ADDENDUM NO. 2
to the
PROJECT DOCUMENTS AND SPECIFICATIONS
for
T-HANGAR DEVELOPMENT

AVCON Project No. 2022.0241.01

Addendum Date: November 7, 2024

ADDENDUM NO. 2
T-HANGAR DEVELOPMENT
Calhoun County Airport

SHEET
A1.11

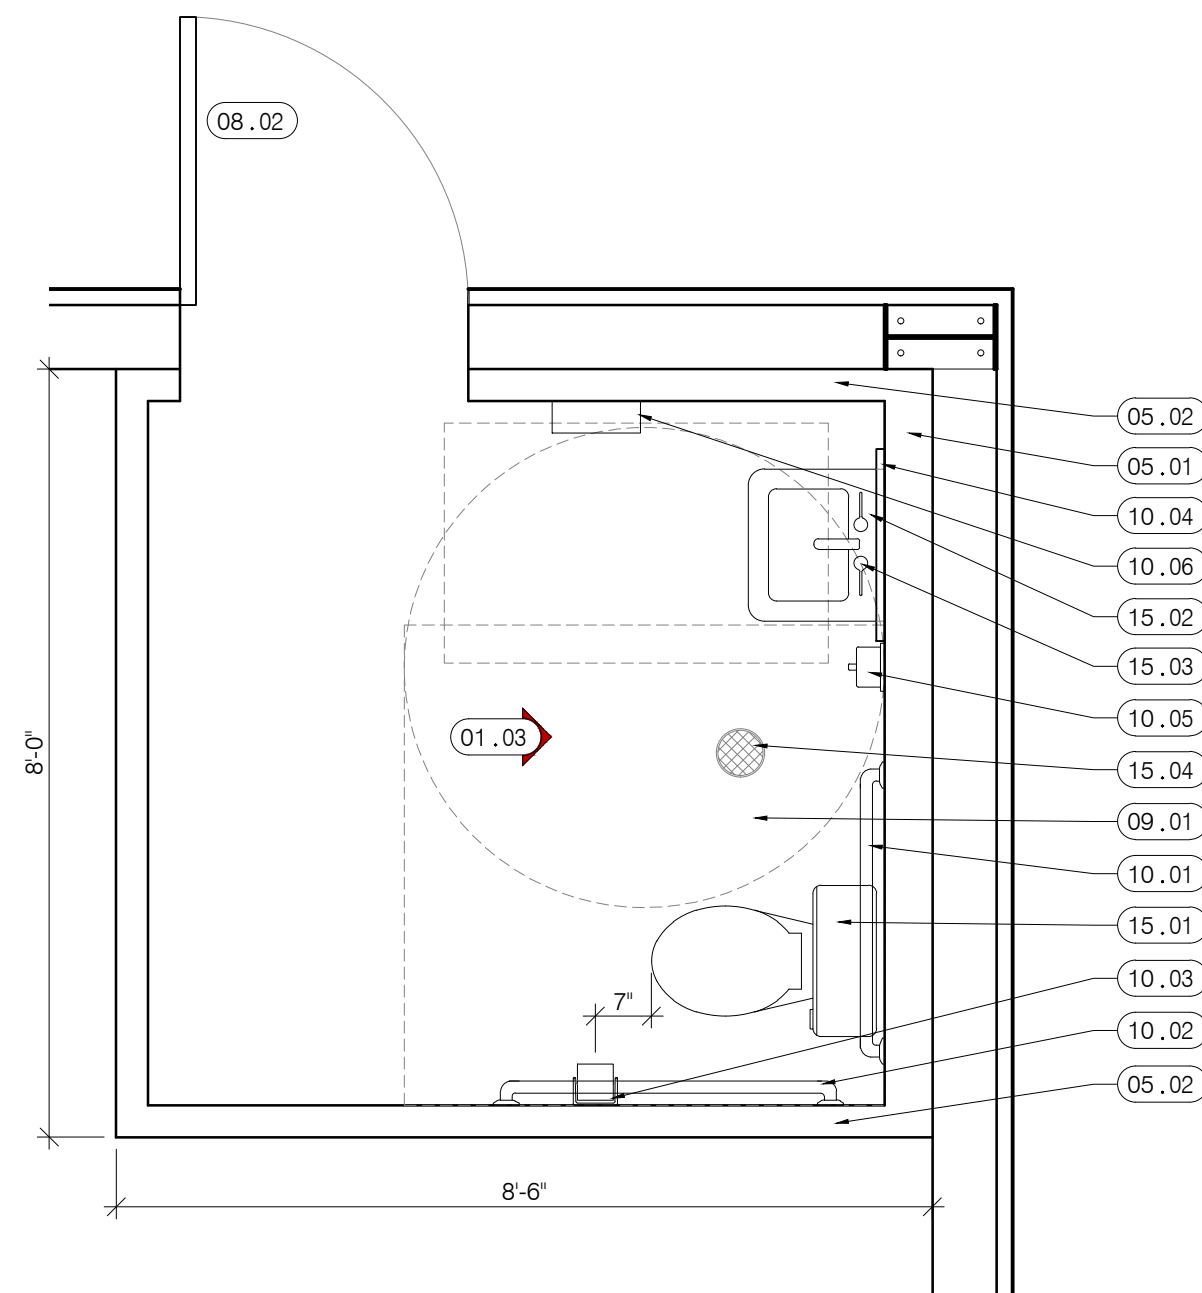
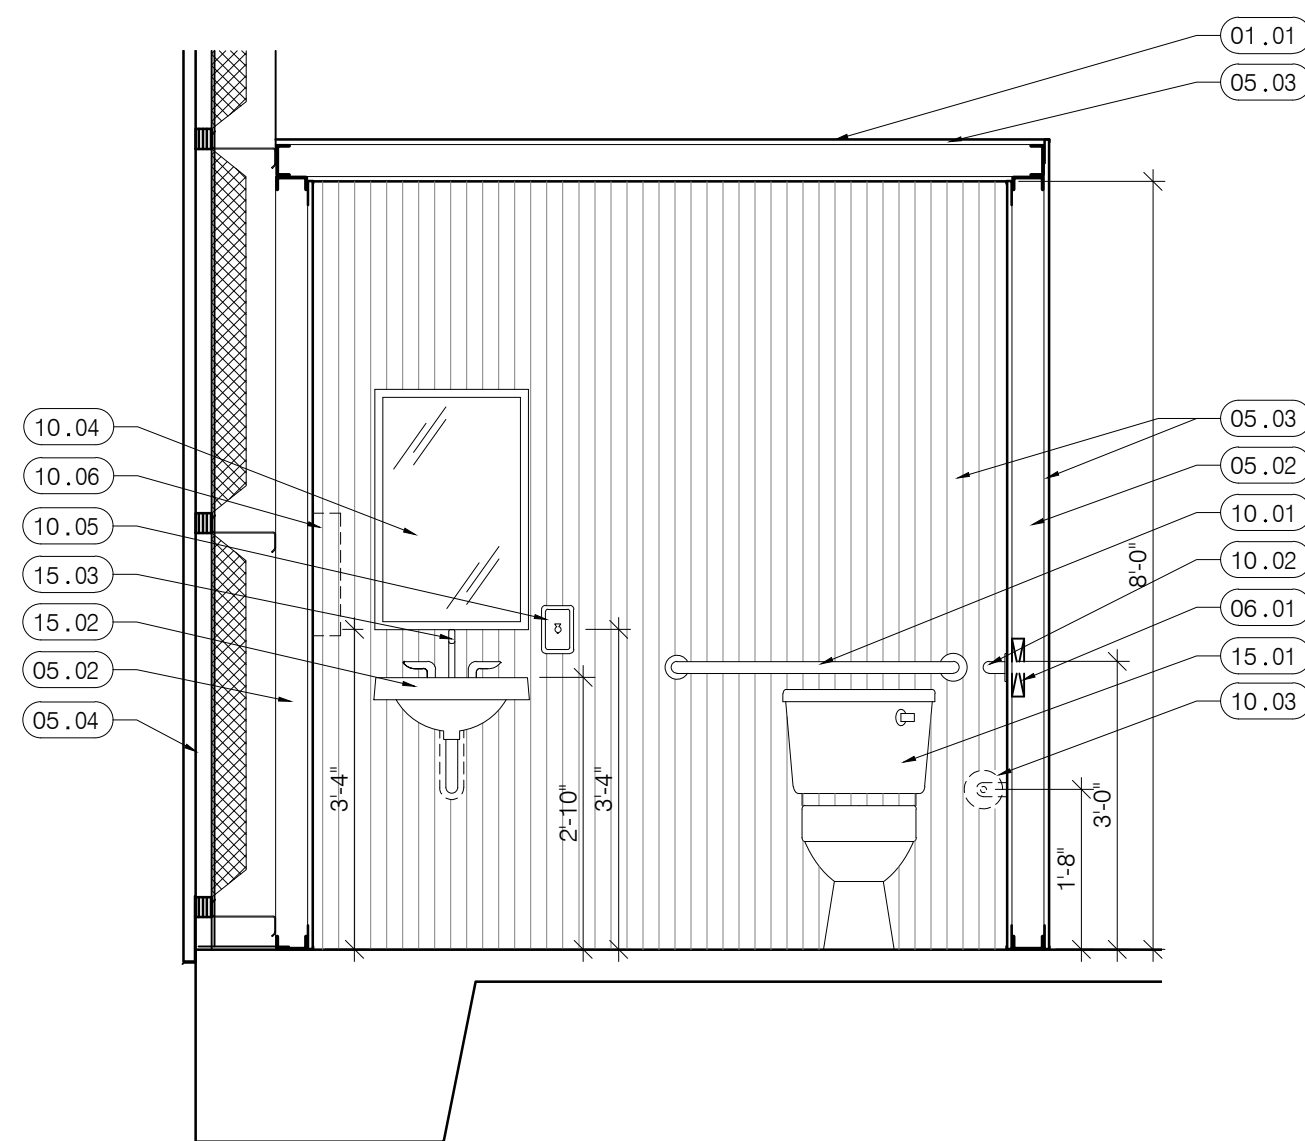
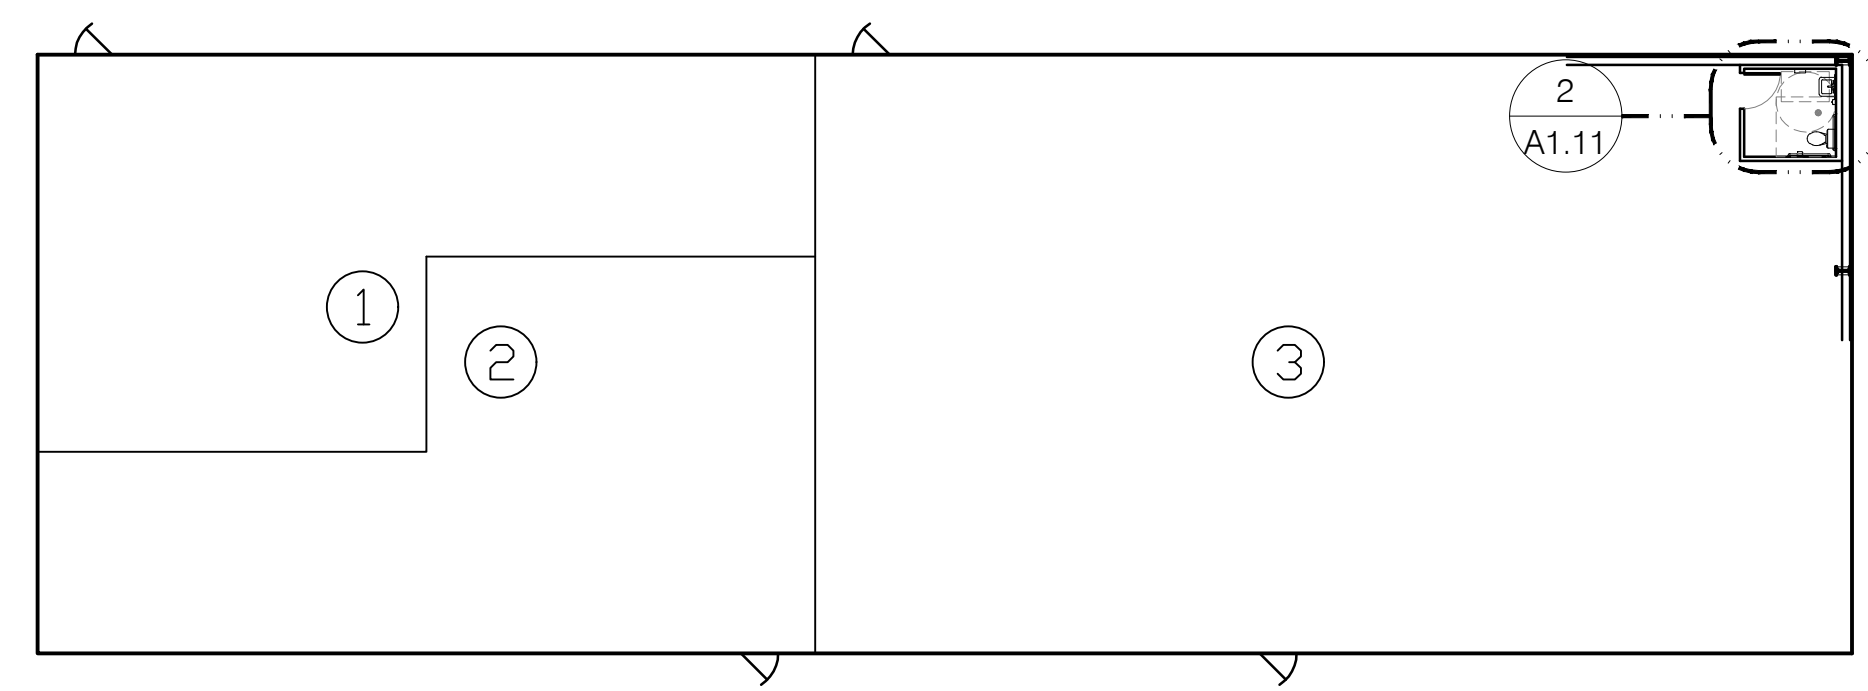
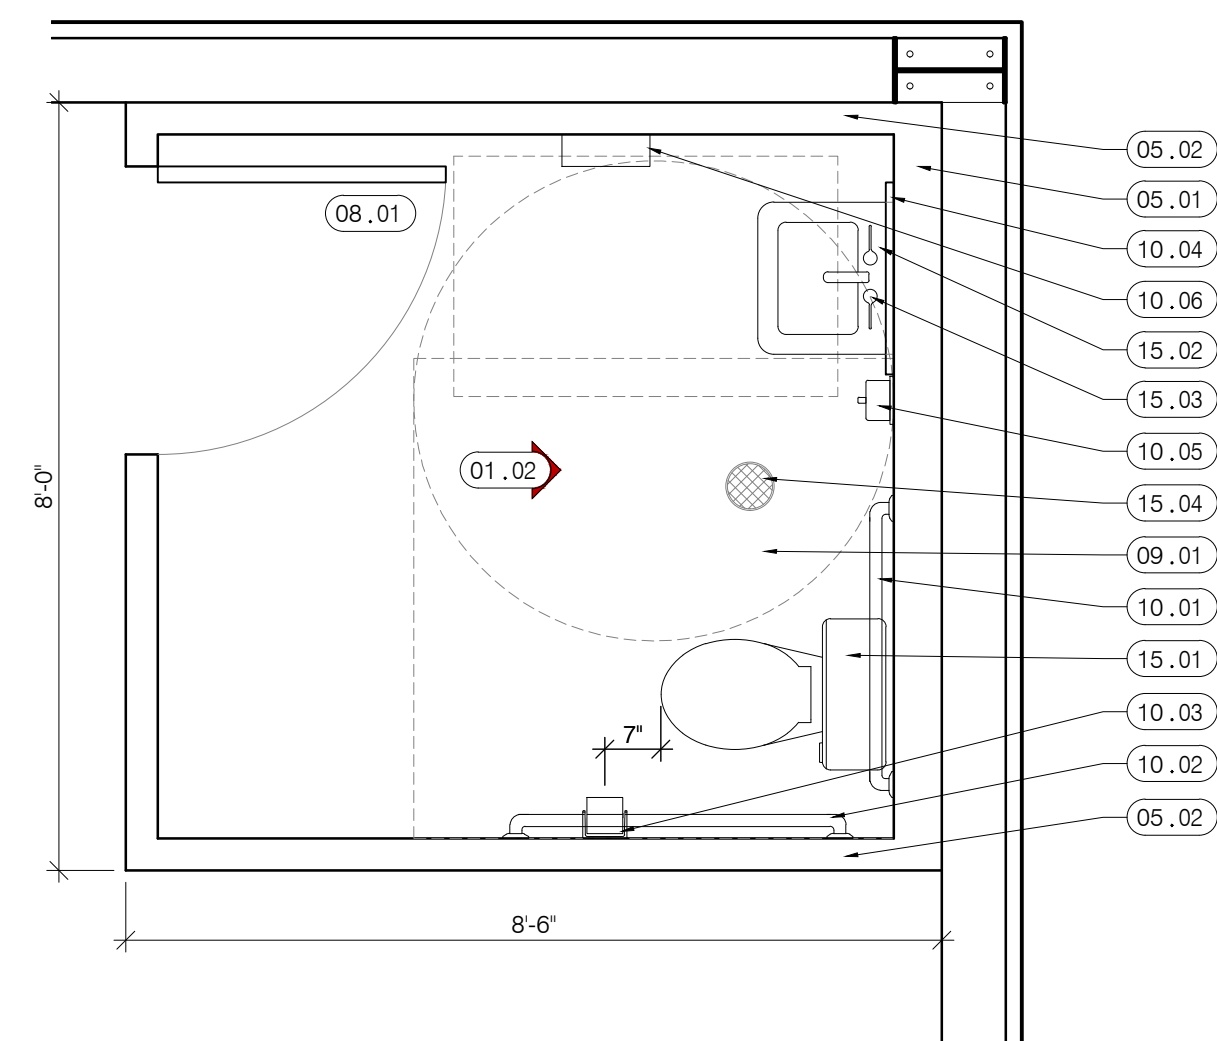
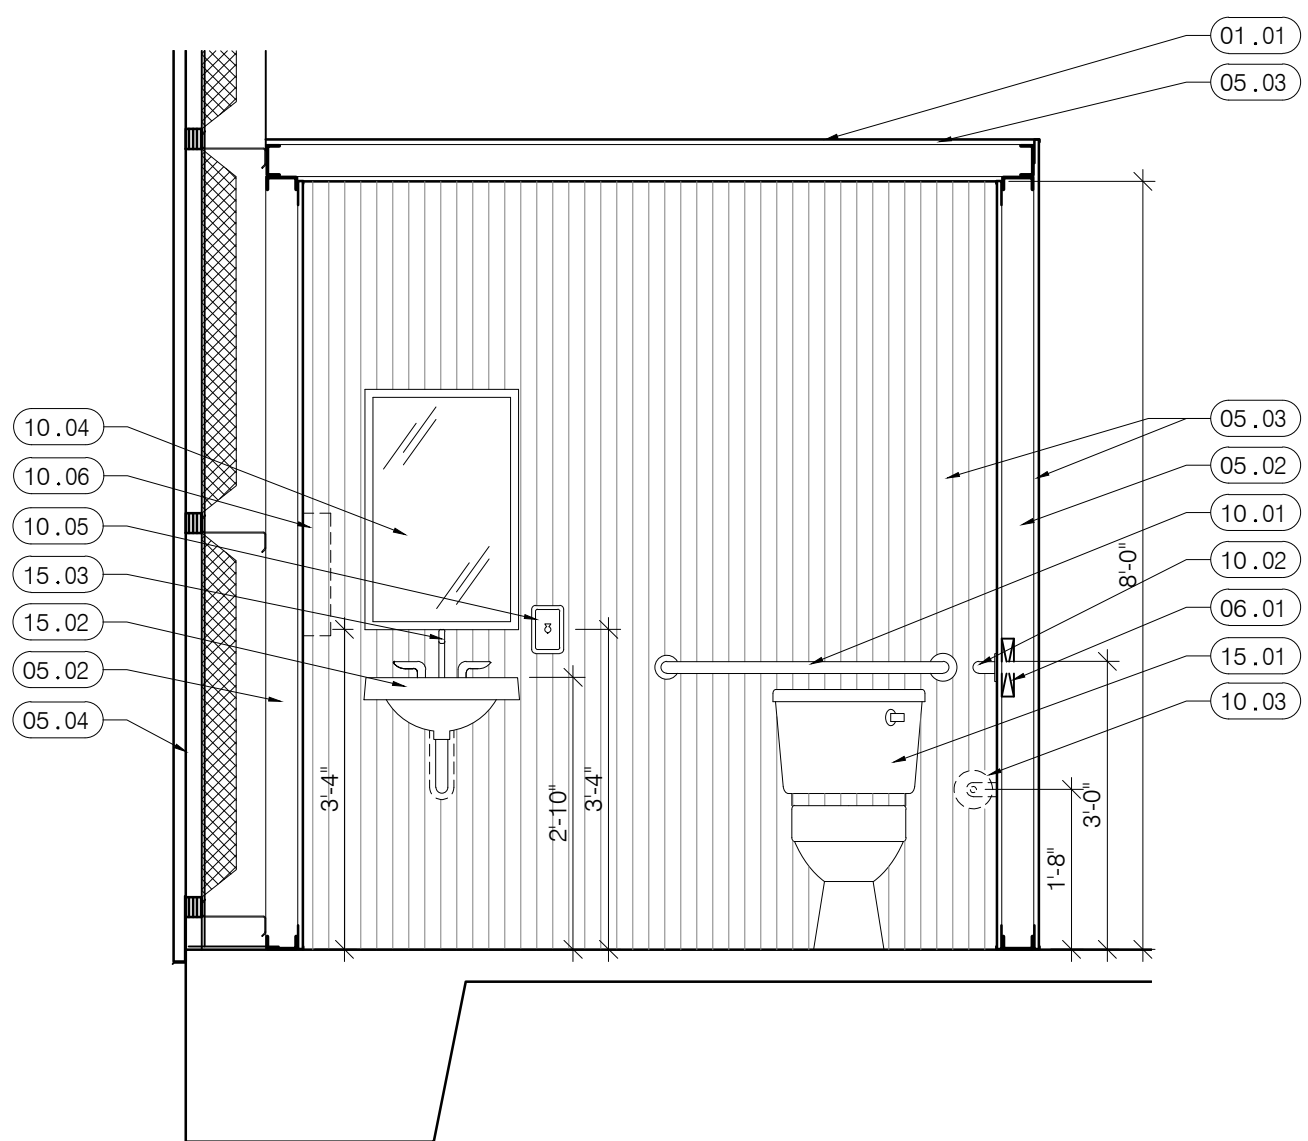
- *Toilet accessory specifications – Toilet accessory specifications are provided in Sheet A1.11 issued in Addendum No. 2.*
 - *Fire extinguisher specifications – Fire extinguisher specifications are provided in Technical Specification H-100: Aircraft T-Hangar Buildings.*

- *Foundation plan – Foundation plan to be provided by the contractor in accordance with requirements on Sheets C-6 and C-8.*
 - *Restroom plan – Restroom plan is issued with Addendum No. 2.*
